Submission by Kingsford South Precinct representing over 5,000 residents in Kingsford

Figure 5.2 Proposed modification to the High Street LRV crossover location

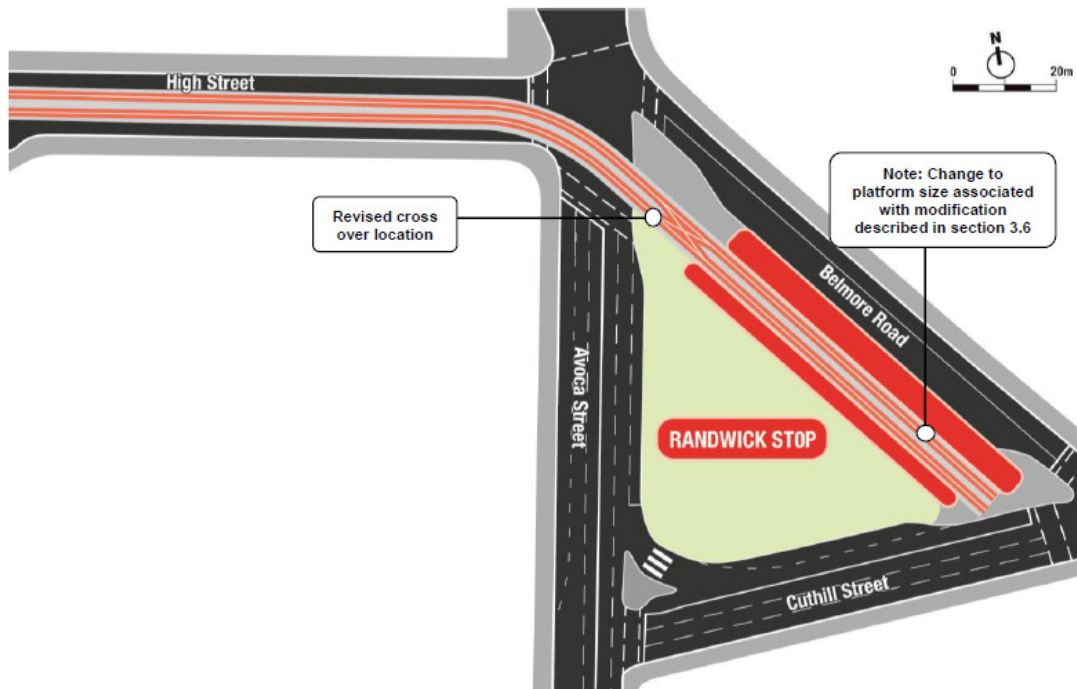
- ◇ Buses required to make a 135 degree turn heading west out of Belmore Rd into Avoca St.
- ◇ Pedestrians forced to compete with train passengers when trying to walk along the footpath along Belmore/Cuthill or Avoca St.
- ◇ Why are the footpaths eating into High Cross Park not shown along the Cuthill St or Avoca St frontages? Misleading and deceptive images.
